# MAD-29-10.61

REPLACEMENT OF BRIDGE DECK ON MAD-29-1061 OVER I-70, RECONSTRUCTION OF APPROACH ROADWAY, FULL DEPTH PAVEMENT REPLACEMENT ON RAMP B, AND DITCH CLEANOUT ALONG SNYDER LANE.

FEDERAL PROJECT NO. E170 (753)  
CONSTRUCTION PROJECT NO. 104867  
RAILROAD INVOLVEMENT NONE  
MAD-29-10.61  
1/76

**FRAMING PLAN & DETAILS**  
 BRIDGE NO. MAD-SR29-1061  
 OVER I.R. 70

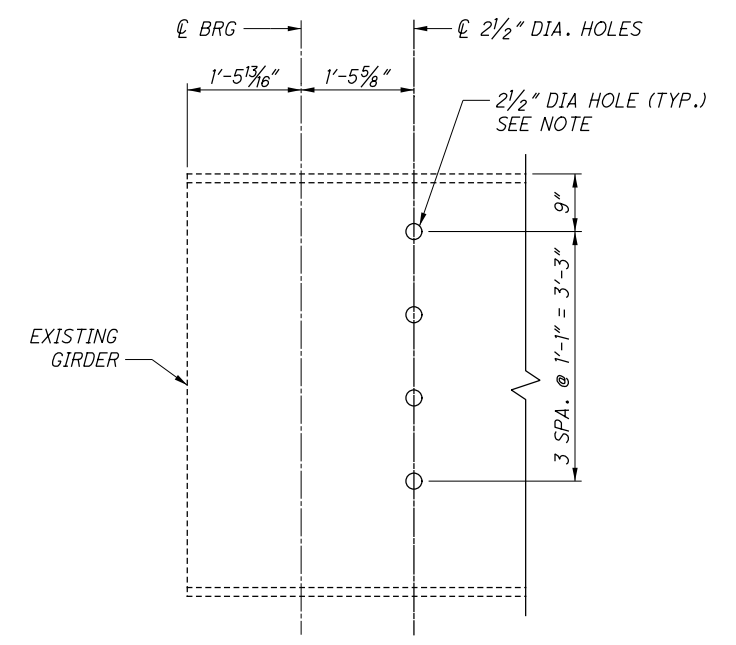
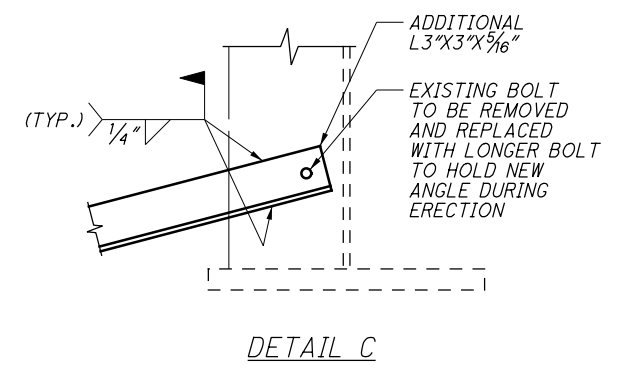
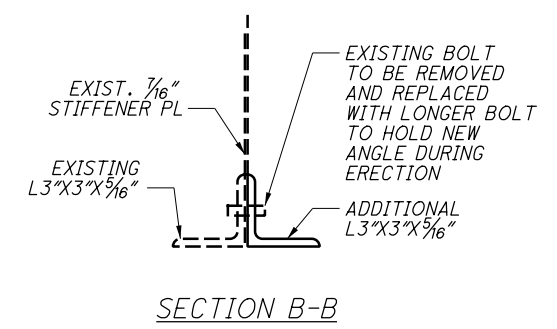
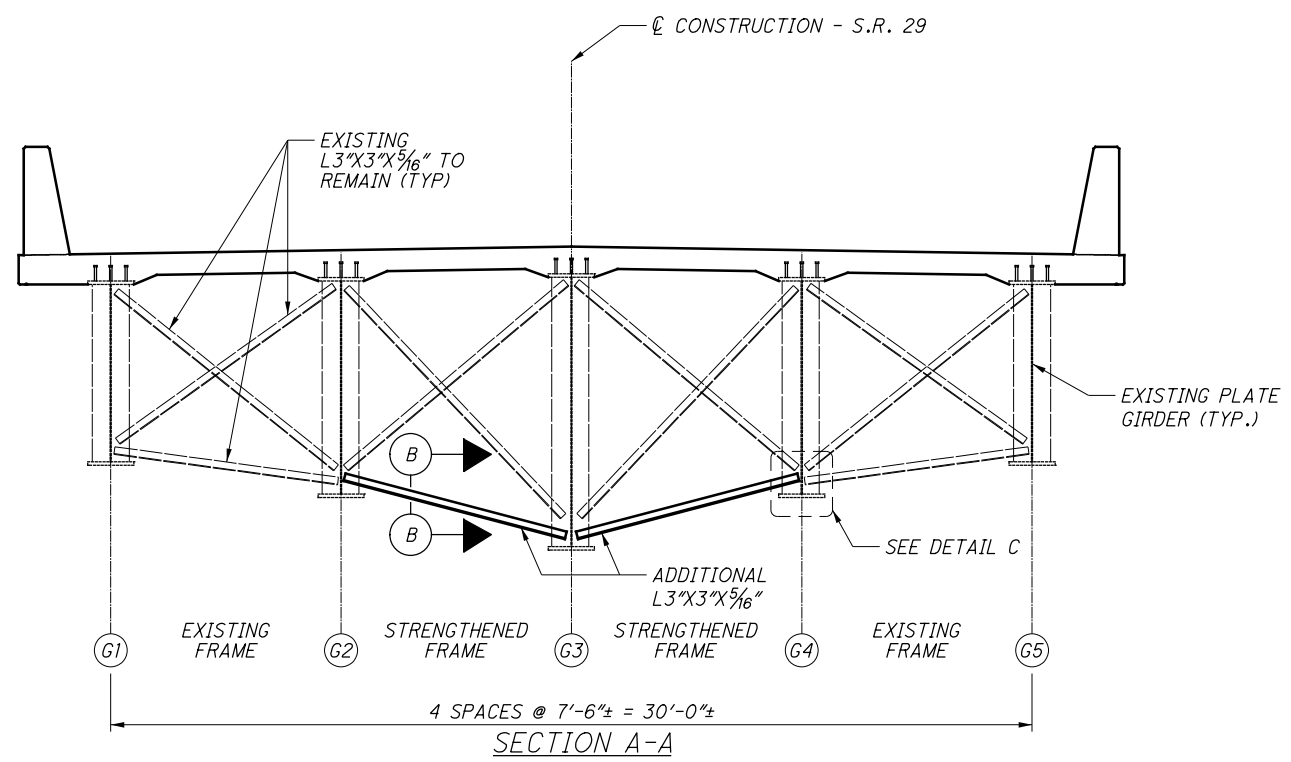
REV.	BY	DATE	DESCRIPTION
GF		09/26/20	REMOVED NOTE
GF		09/23/20	ADDITIONAL BRACING

**NOTE:**  
 PROVIDE NEW INTERMEDIATE CROSS-FRAMES AT LOCATIONS SHOWN ON THE FRAMING PLAN. THE CROSS-FRAMES SHALL CONNECT TO THE EXISTING GIRDER STIFFENERS. HOLES FOR THE 3/4-INCH DIAM. BOLTS SHALL BE FIELD DRILLED AND THE ANGLES (L 3" X 3" X 5/16") WELDED AS SHOWN IN DETAIL C THIS SHEET. PAYMENT FOR ALL WORK ASSOCIATED WITH THE ADDITIONAL BRACING SHALL BE INCLUDED IN ITEM 513: STRUCTURAL STEEL, MISC.: ADDITIONAL INTERMEDIATE BRACING MEMBERS.
